## TOWN PLANNER QUESTIONS, COMMENTS AND RECOMMENDATIONS #3

### 17 Rice Road

<b>Application:</b>	Ch. 40B Comprehensive Permit
<b>Applicant:</b>	SJV Investments, LLC
<b>Location:</b>	17 Rice Road Map 63; Lots 75, 75A, 75B, 75C & 144
<b>Application Submitted:</b>	October 31, 2023
<b>Legal Ad Publication Dates:</b>	November 9, 2023 & November 16, 2023
<b>Public Hearing Opened:</b>	November 29, 2023

Comments based on the site plan entitled “*Rice Pond Village Site Plan of Land in Millbury, MA*”, dated October 24, 2023, revision date of February 19, 2024, prepared by Azimuth Land Design, LLC.

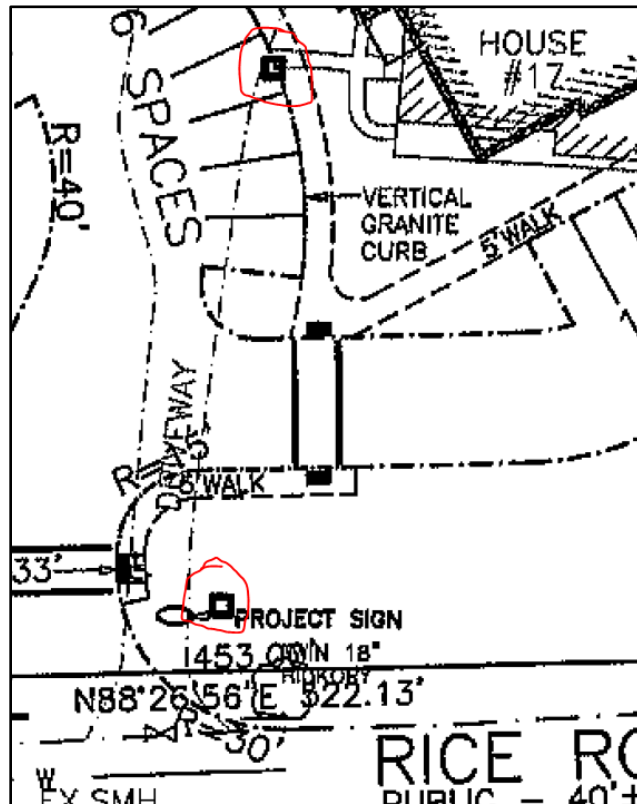
- c. Section 3.13.2.7 – A table showing the zoning requirements for the site should be provided on the site plan.

A table showing zoning requirements has been provided. However, the Land Plan sheets still incorrectly label the site as being the R-I zoning district and provide the zoning requirements for that district.

The Applicant noted the zoning information on the Land Plan sheets will be updated on the next iteration of the plans.

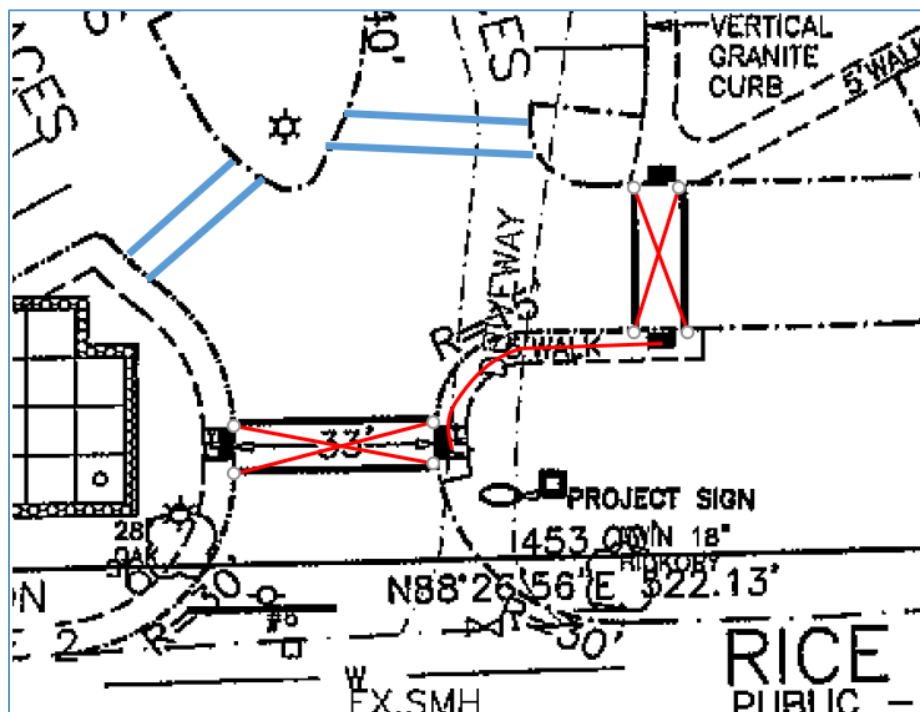
The Applicant should provide additional detail on mitigation and protections for the trees that adhere to recommendations of the Tree Warden and arborist.

Given that these trees are subject to M.G.L. Ch. 87 public shade tree laws and the Tree Warden's requested protection of the Critical Root Zone, the Applicant should evaluate moving site features outside of the CRZ, including infiltration basin #3, the temporary settling basin, and the sidewalk on the east side of the site driveway entrance.

The Applicant met with the Tree Warden, the Warden's arborist, and myself onsite to review protection of the public shade trees. The Applicant agreed to move Infiltration Basin #3 farther away from the CRZ and to partially eliminate the sidewalk on the east side of the driveway entrance. These changes are reflected on the plan.

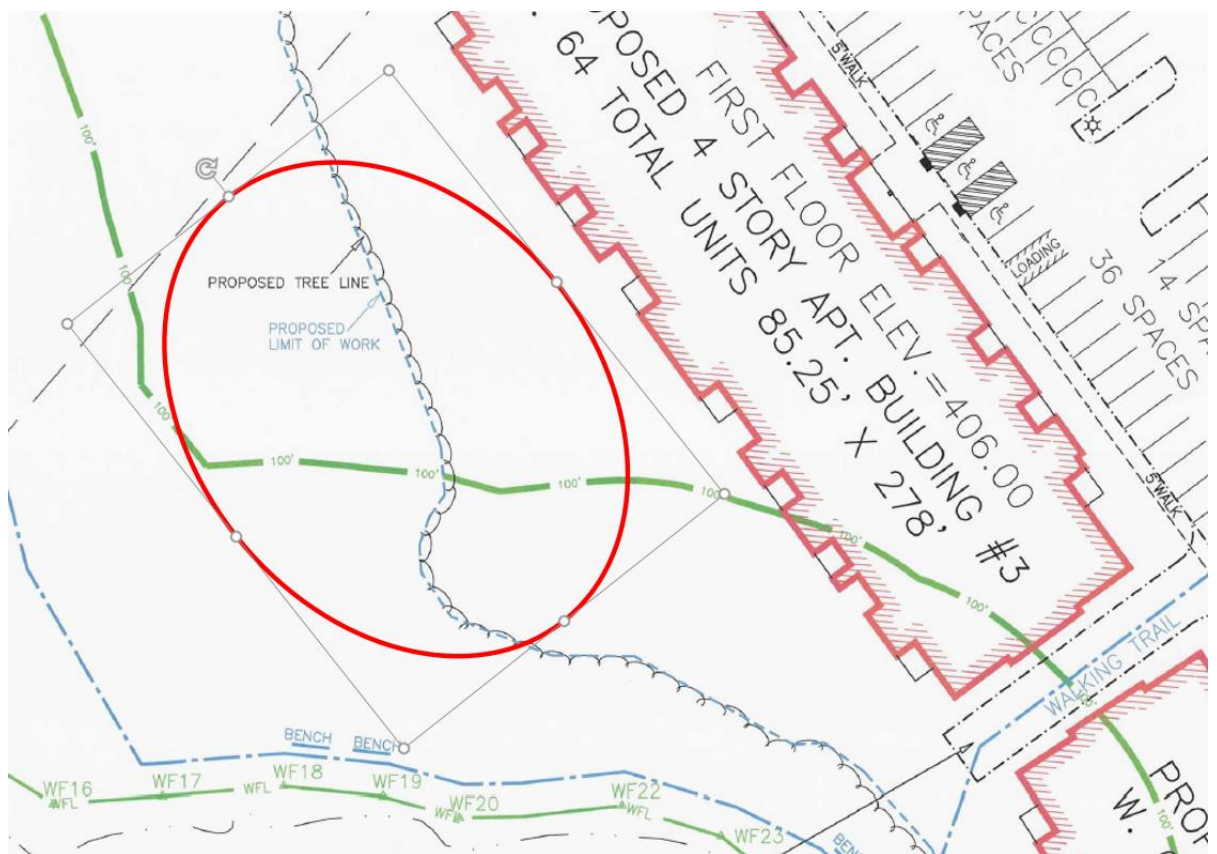
13. **Given the potentially large number of residents on the property, suggesting the Applicant provide fencing along the parcel's boundary with the railroad for safety purposes.**

**The Applicant noted they would consider installing a fence. In review of the Planning Board public hearing materials, the Applicant identified a deed from 17 Rice Road requiring the railroad to provide a fence along the property boundary. Recommending the Board include this requirement as a condition of approval and the Applicant can**

work out the responsibly party for installing the fence between themselves and the railroad.

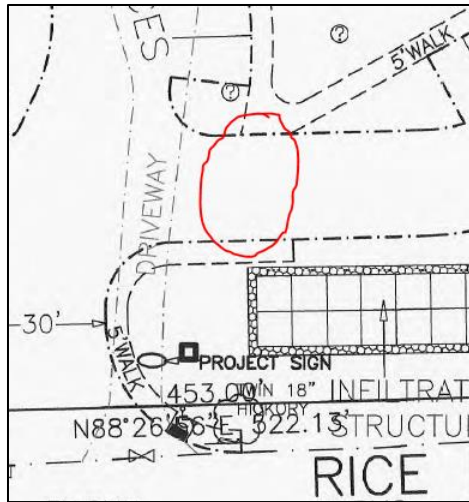
- j. Section 3.13.5.5 – Sheet D2 shows a detail for a guardrail but a guardrail does not appear on the site layout sheets. Please identify the location of the guardrail on the site plan.

**This comment has been addressed.**
